ADDENDUM #1

10 July 2012

RE: Eli Whitney CTHS
Additions & Renovations Project
71 Jones Road
Hamden, CT 06514
Job Nos.: Department of Construction Services – BI-RT-837 / Antinozzi Associates - 04210

FROM: ANTINOZZI ASSOCIATES, P.C.

49 TYPICAL ROOF EDGE FLASHING DETAIL
 SCALE: 3" = 1'-0"

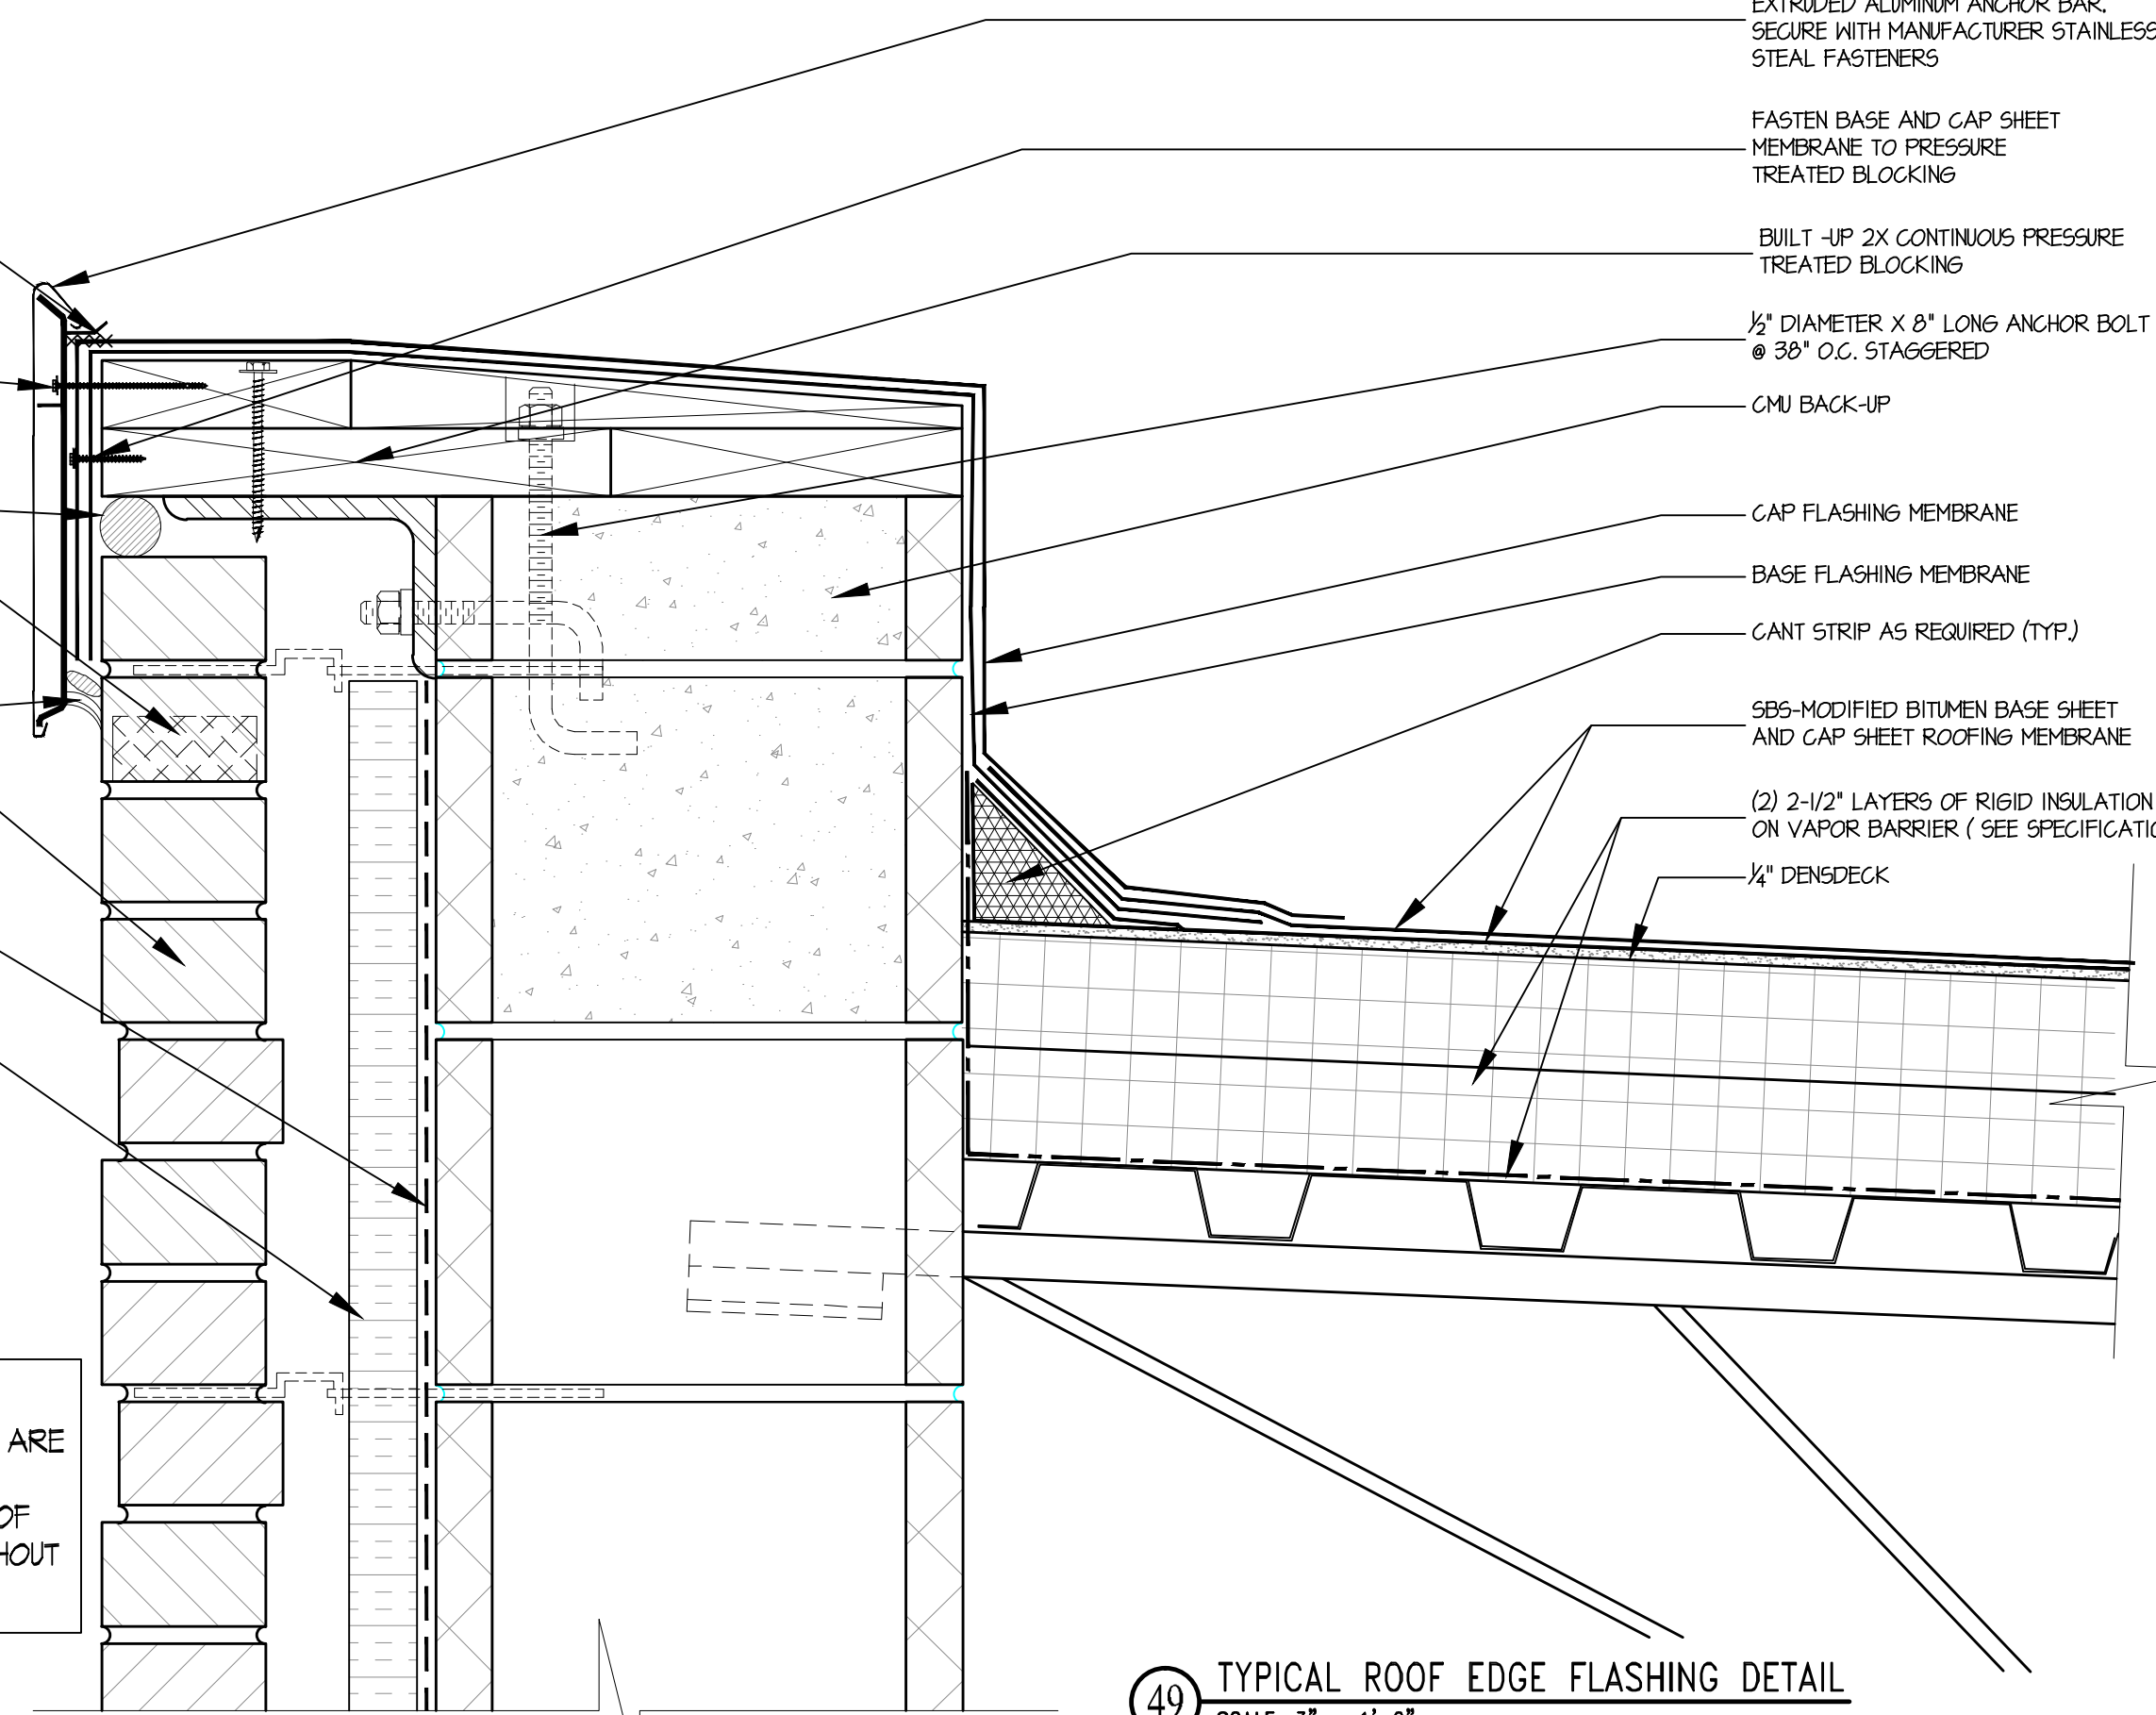
3) **A-110.8** – Roofing Details

- a) Insert Detail 49/ SKA01 (Typical Roof Edge Flashing Detail)

4 TYPICAL BASE OF WALL FLASHING DETAIL
SCALE: 3" = 1'-0"

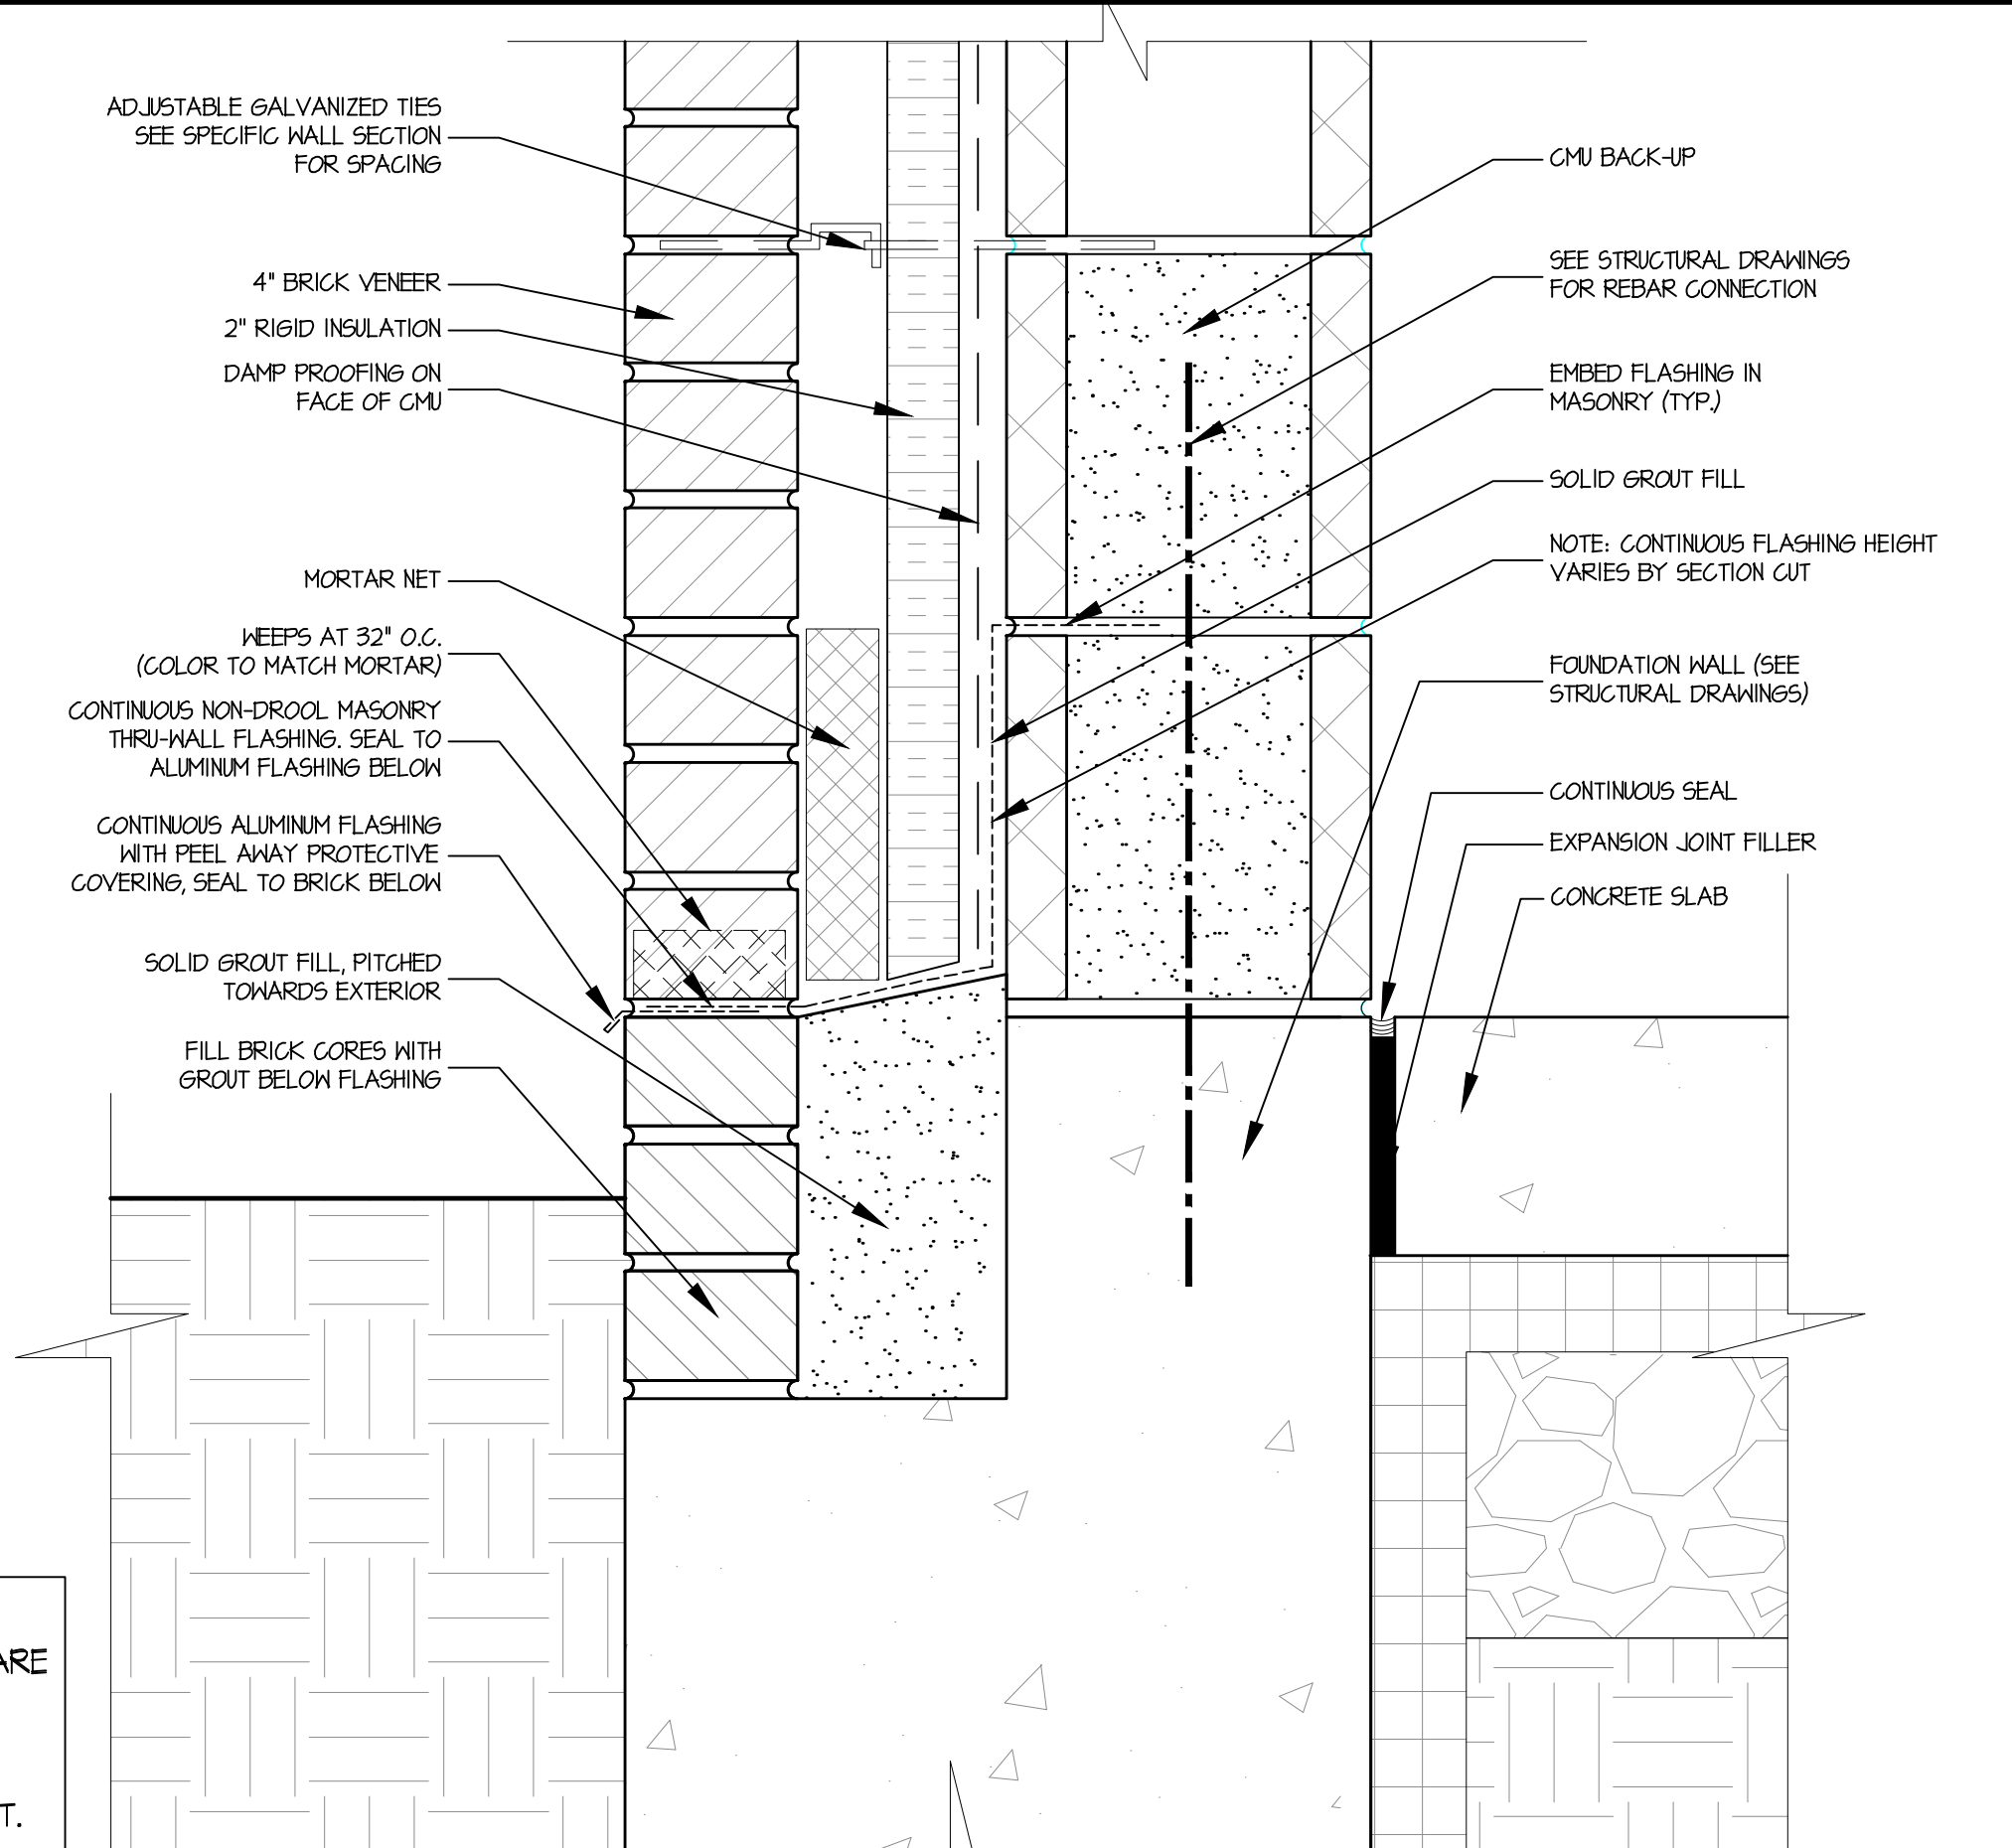
5) **A-515** – Wall Sections

- a) Insert Detail 4/ SKA02 (Typical Base of Wall Flashing Detail)

DRAWING TITLE:
 REVISED AREA B1 MAIN LEVEL PLAN (PARTIAL)

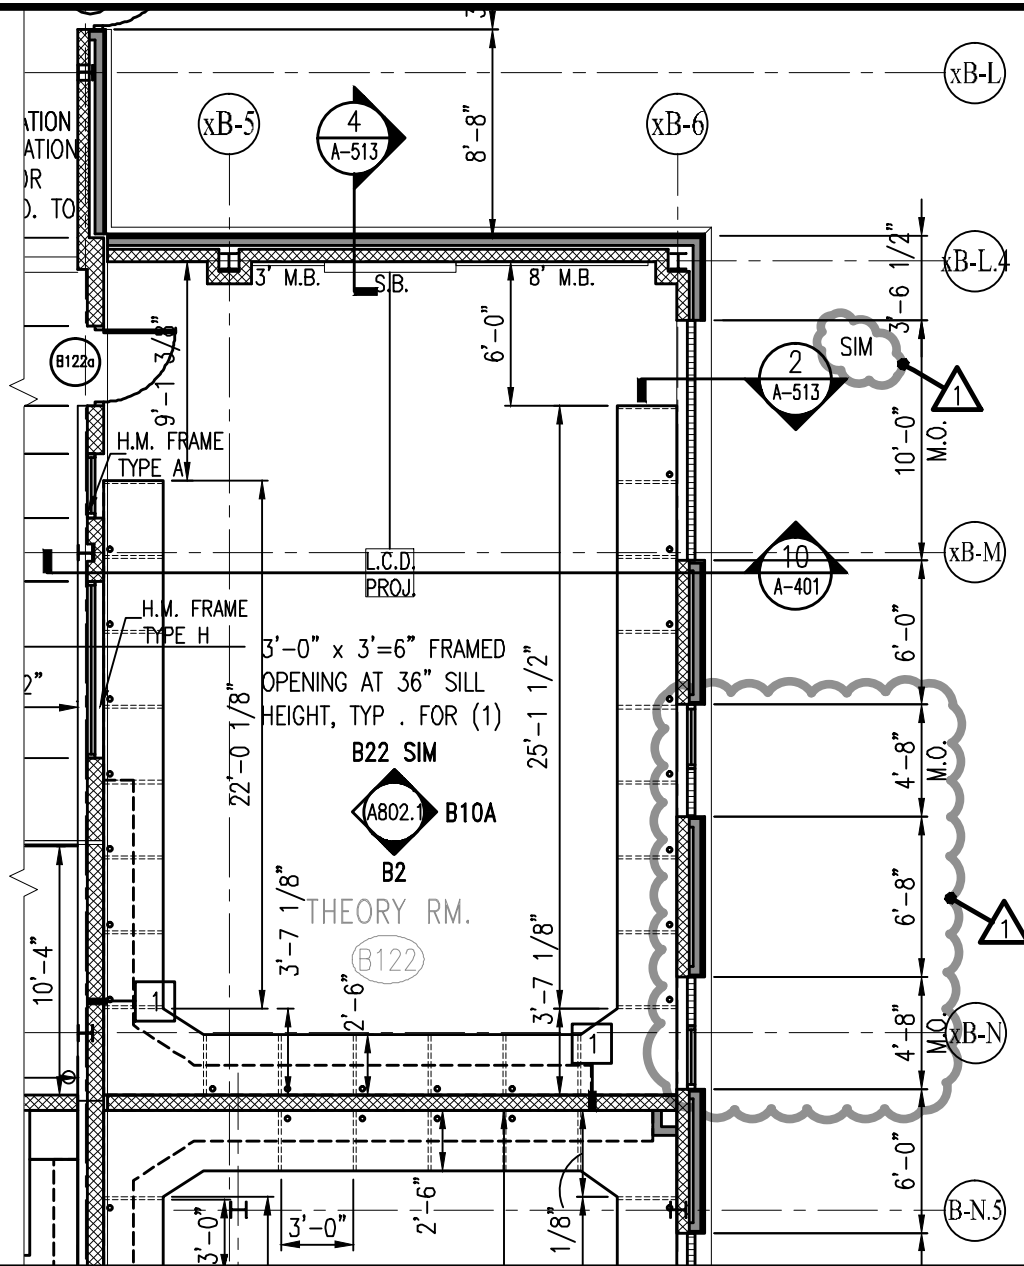
- a) **Question:** Refer to drawing A102.1. There is a wall on the xB-4 line from approximately xB-T to xB-L4 that is new CMU. This same wall seems to be noted on drawing D103 as mostly existing and to remain. Please clarify. **Answer:** Insert the following note along Column Line xB-4, from the door to be demolished adjacent to Column Line xB-T to Column Line xB-L.4 – “Remove CMU/Brick partition of varying height in its entirety.”

- a) **Question:** Refer to drawing A102.1. There is a wall on the xB-4 line from approximately xB-T to xB-L4 that is new CMU. This same wall seems to be noted on drawing D103 as mostly existing and to remain. Please clarify. **Answer:** Insert the following note along column line xB-4, from the jamb at door B132c to Column Line xB-L.4 – “New 8” CMU partition from floor to underside of roof deck above as per Detail 4/A-510. Drill, Epoxy, then grout #4 Re-Bars vertical into existing slab/foundation 12“ minimum, at 32” O.C. and 2’-0” into new grout filled CMU. See Structural Drawings for details and required lintels at openings in new partition.”

- a) Drawing **A-303** – Exterior Elevations B-Building: Insert revisions to Detail 2A/A-303 as shown on Drawing SKA-04 - Revised Partial B-Wing - West Elevation (Partial)
- b) Drawing **A-102.1** – Area B1 Main Level Floor Plan: Insert revision as shown on Drawing SKA-03 - Revised Area B1 Main Level Plan (Partial)
- c) Drawing **A-513** – Wall Sections Wing B: Insert revisions to Details 2/A-513 as shown on Drawing SKA-05 - Revised Wall Section at B-Wing (Partial), and Detail 3/A-513 as shown on Drawing SKA-06 - Revised Wall Section at Wing B (Partial), and revisions to details A/A-513, B/A-513, C/A-513, & D/A-513 as shown on Drawing SKA-07 - Revised Head/Jamb/Sill Details.
- d) Drawing **A-920** – Window / Curtainwall Schedule: Insert the revisions as shown on Drawing SKA-08 - Revised Window Types (Partial).
